## Application for Licence Amendment

### Part V Division 3 of the *Environmental Protection Act 1986*

<b>Licence Number</b>	L8148/2006/4
<b>Licence Holder</b>	Koolan Iron Ore Pty Ltd
<b>ACN</b>	099 455 277
<b>File Number</b>	DER2014/000374-1
<b>Premises</b>	Koolan Iron Ore Mine and Port Facility Mining Tenements M04/416, M04/417, L04/68 and L04/29 Koolan Island (Buccaneer Archipelago) WA 6733  As defined by the map in Schedule 1 of the Revised Licence
<b>Date of Report</b>	26 August 2024
<b>Decision</b>	Revised licence granted

Figure 2 – Existing stormwater infrastructure and proposed low flow surface water drain

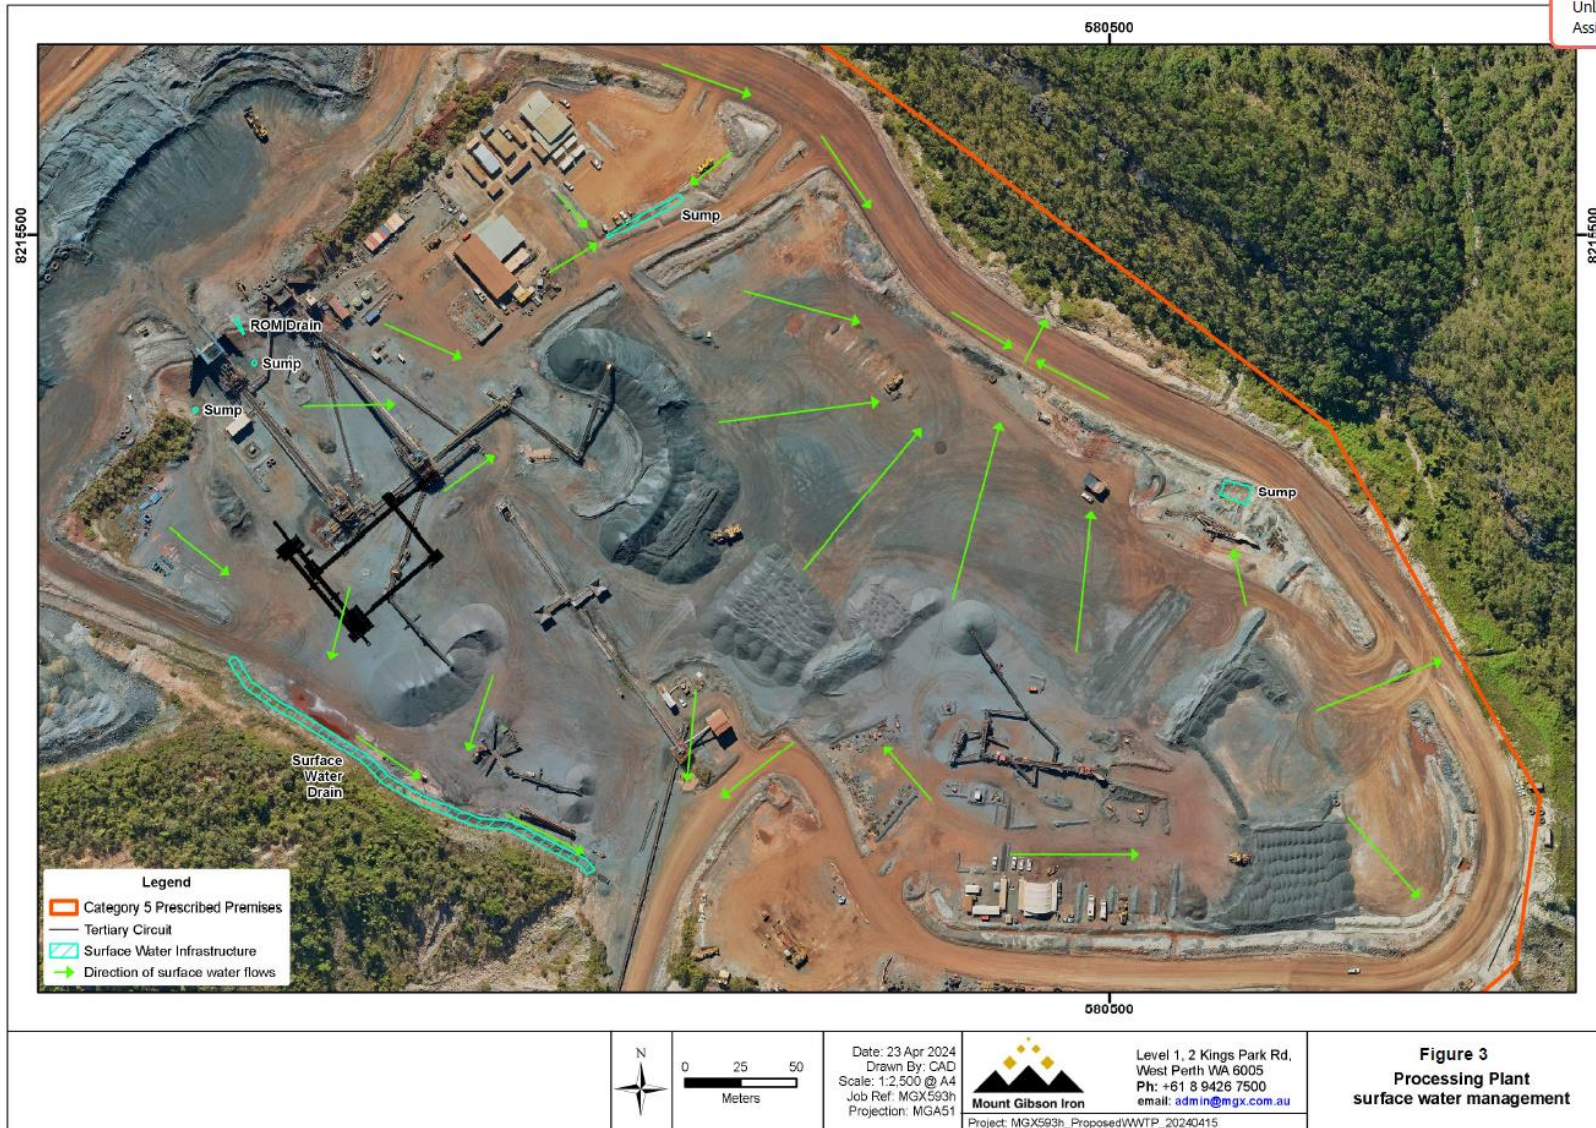
The Licence holder was requested to provide further information on stormwater management within the process plant area to ensure current controls are sufficient to manage storm water within the proposed new tertiary circuit.

The Licence holder initially considered the installation of a sump (if necessary) to contain the eastward moving stormwater runoff as there is currently no containment system in place; however, there are constraints on sediment retention sumps on Koolan Island as they need to be extremely large to either contain surface water for disposal via infiltration or otherwise retain surface water for sufficient duration to allow sediment to be removed from suspension.

The Licence holder preferred solution is to reconfigure the existing surface water drain from a simple W-style surface drain to a low-flow filter drain, in the location shown in Figure 2. The filter drain is a sub-surface drainage solution consisting of perforated or slotted pipe within a gravel-filled open trench.

- 191m total length
- 1% longitudinal grade
- 3.7m wide x 0.5m deep open channel
- 1 in 1.5 sideslopes
- Perforated/slotted pipe(s) of at least 160mm diameter

- the flow coming off the sub-catchment peaks at 0.89 m<sup>3</sup>/s in the 1 EY event and 1.56 m<sup>3</sup>/s in the 10% AEP event.
- the channel specification (as described above), modelled at 1% grade and based on actual dimensions would handle the 10% AEP storm event, but would overtop during larger events.

The capacity of the filter drain relates primarily to the volume of voids within the drain. With an estimated 35% void space, a 0.5m depth of gravel will result in up to 175mm of storage capacity for capturing the first flush, which the licence holder indicated to be sufficient. The gravel within the drain does not require a longitudinal grade to promote flow through, it is simply a storage media and the eastern end of the gravel drain would be blocked off to prevent longitudinal flow. As indicated above, the open channel will convey excess rainfall above and beyond the storage capacity of the gravel.

**Figure 3 – Existing WWTP and proposed infrastructure.**

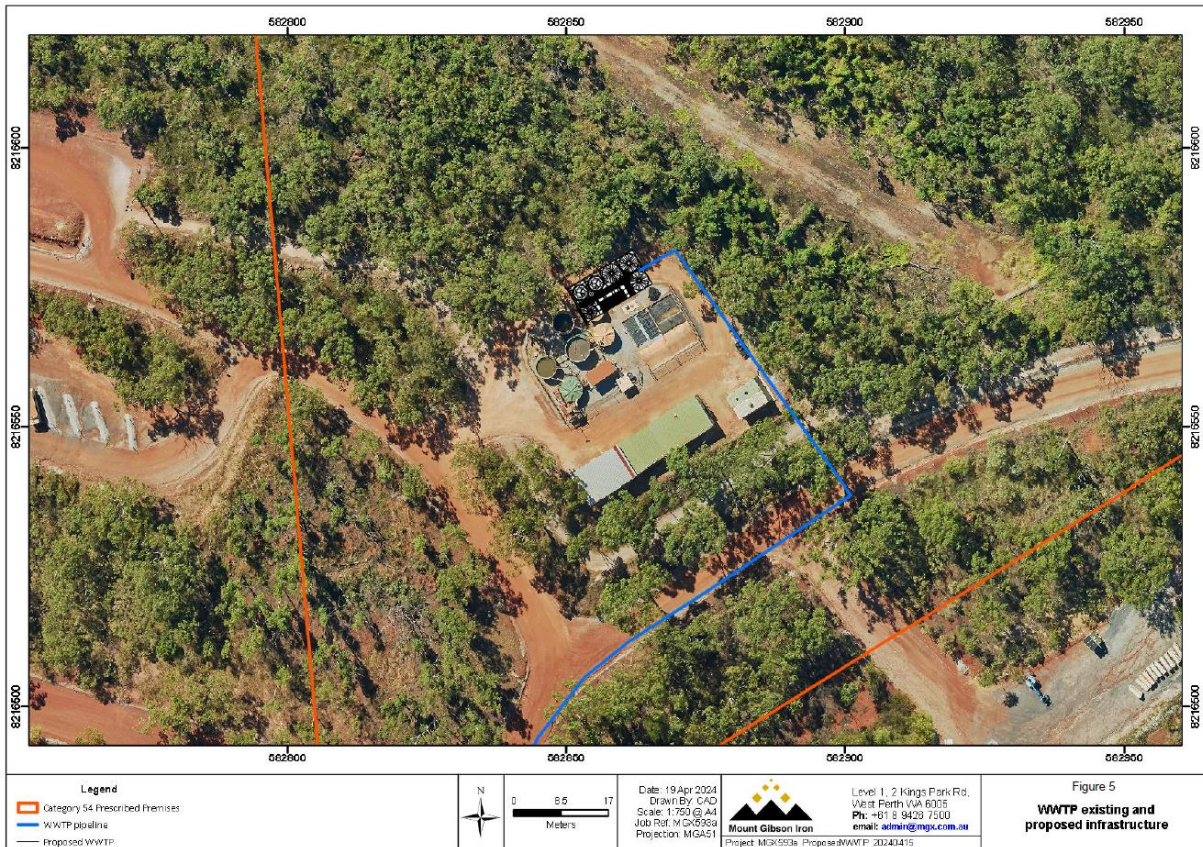
The Licence Holder proposes to construct and operate a new WWTP to replace the existing WWTP which is reaching its end of life (Figure 3). The new WWTP will be a skid mounted moving bed bio reactor (MBBR), rather than another dual stage WWTP. The MBBR is claimed to be a more efficient, reliable, modern and safe system and is intended to service the mining camp for the remaining lifespan of the project. Select existing infrastructure such as the drying beds will remain in service with the new system.

The MBBR will have a design capacity of 130 cubic metres (m<sup>3</sup>) per day, therefore the Licence Holder requests to have the assessed design capacity limit on the licence increased to 130 cubic metres per day. However, the Licence Holder expects the MBBR will process the current assessed throughput of about 100 m<sup>3</sup>/day.

**Figure 4 – Proposed new irrigation field (in pink) and associated pipeline. Orange boundaries include existing/proposed WWTP and existing irrigation fields.**

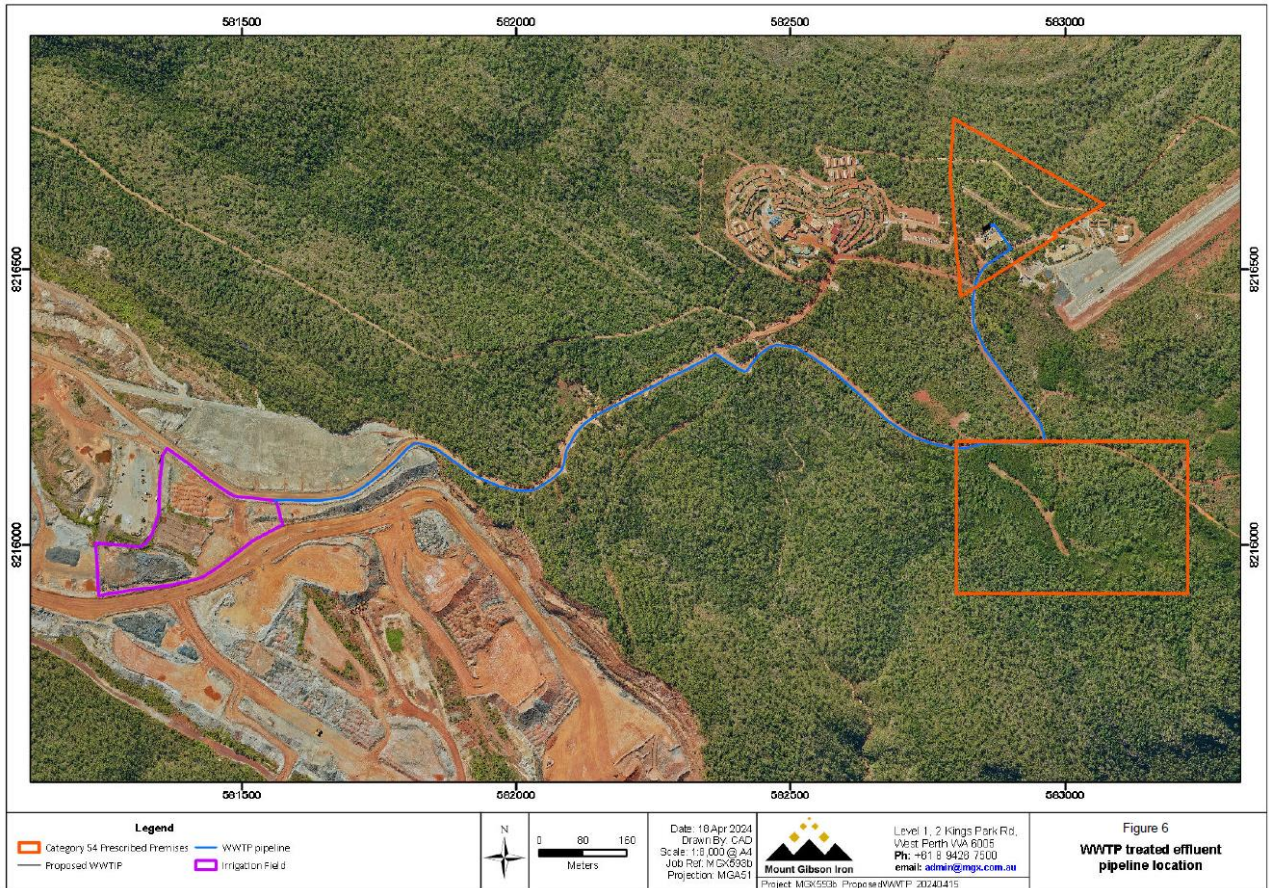
During assessment the licence holder informed that the discharge of reject water (saline water) from an existing potable water treatment plant is also planned to be discharged into the new 3.3 ha irrigation field (L4) and existing irrigation field L2 (used as a backup only). The Village reverse osmosis plant will produce approximately 100 kL of reject water per day. The activity (water desalination plant) does not trigger the threshold under Category 85B, and the applicant has confirmed it will not be mixed with WWTP effluent, however, will be co-disposed. The reject water to be discharge was considered in this assessment, to ensure the proposed irrigation field capacity is sufficient to manage the proposed effluent discharge. However, the construction and operation of the water desalination plant is not assessed and managed through this licence amendment. General provisions of the EP Act still apply.

The licence holder confirmed the reject water volume was considered in sizing of the proposed and existing irrigation fields. The sizing was based on the Department of Health guidelines as well based on recent modelling undertaken.

- A calculation based on DWER's Water Quality Protection Note-22 and the Department of Health guidelines has been performed for the irrigation area based on maximum potential irrigation (including reject water from desalination). The nutrient retention capacity of the irrigation area is not exceeded (high iron soil type D for a sandy loam) overall and the water will infiltrate into the benign waste profile during the period of operation.

The existing L1 and L2 irrigation field will continue to operate for rotation of treated wastewater from the WWTP if required, based on inspections on the new field. The capacity of the L1 and L2 irrigation area has been re-assessed by the Licence Holder and determined to have a maximum capacity of 23KL/day (each) during the dry season.
